STAFF RECOMMENDATION
418 Fairfax Avenue
December 19, 2018

Application: Partial Demolition; New Construction—Addition
District: Hillsboro-West End Neighborhood Conservation Zoning Overlay
Council District: 18
Map and Parcel Number: 10410014400
Applicant: Hunter Conley, Allard-Ward Architects
Project Lead: Sean Alexander, sean.alexander@nashville.gov

Description of Project: The applicant proposes to construct a new rear addition to the house. The addition will include a two-story component and one-story components, and will go wider to the left side of the historic house.

Drawings:
 Demolition Plans
 Date:
 11.29.18

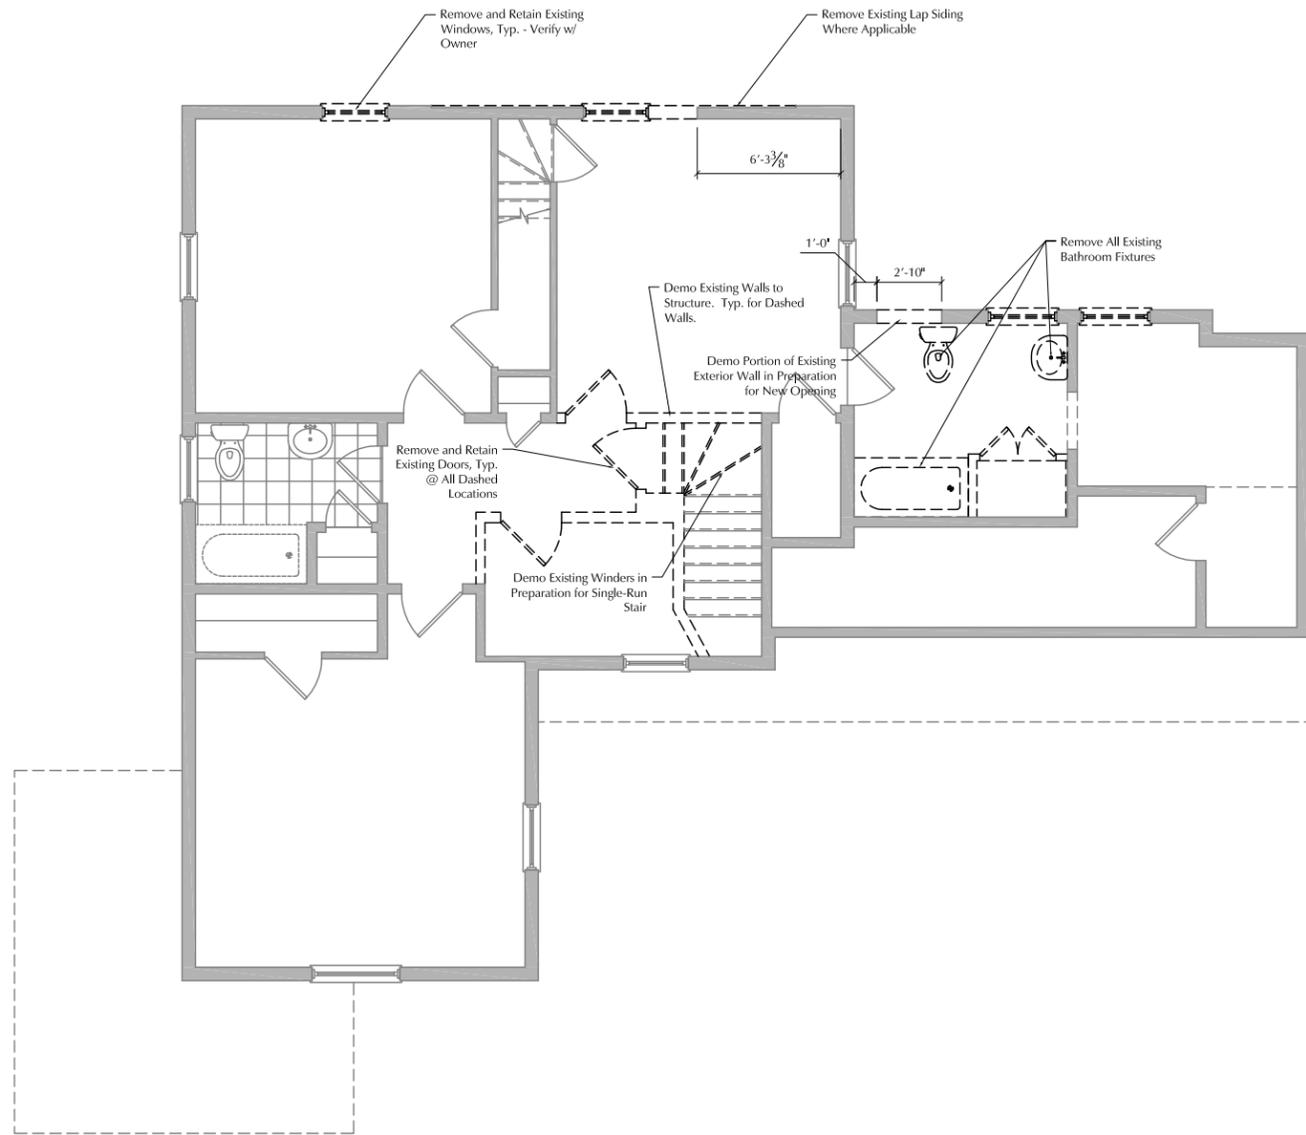
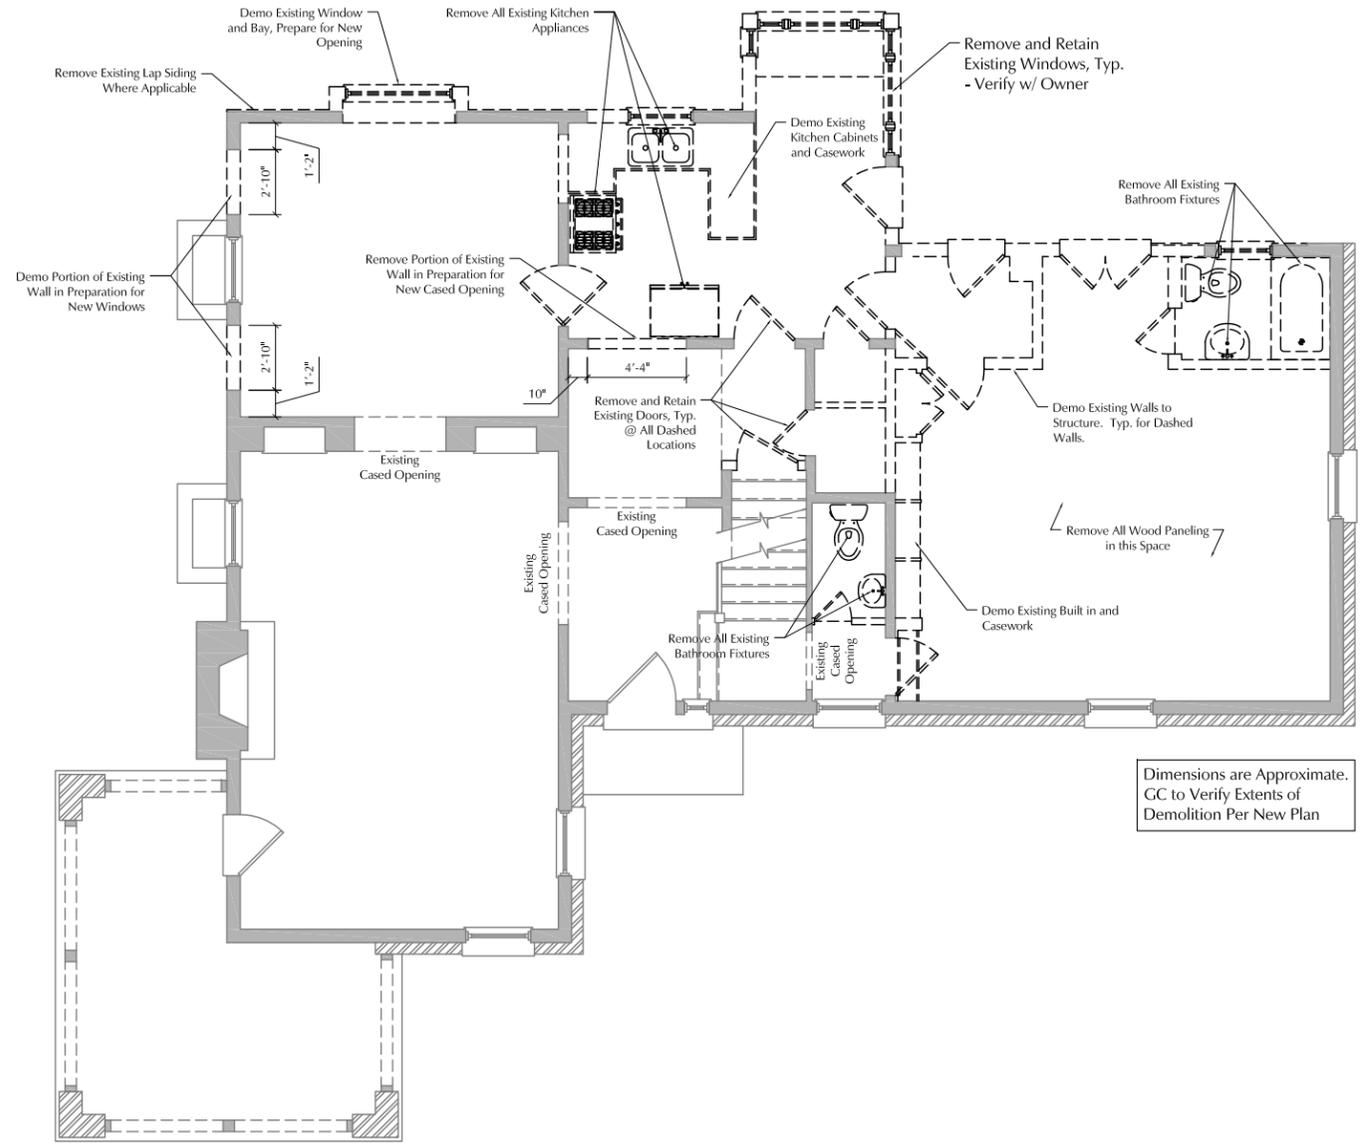
Demolition: Portions of the rear of the building will be demolished to accommodate the new addition and two new window openings will be created on the left side of the house. These new window openings are obscured from view behind the original porch. The new openings on the left will be partially obscured because they are located behind the existing porch. Otherwise the front and side facades of the house will not be impacted. Staff finds the partial demolition to be appropriate and to meet section III.B.2.b of the design guidelines.
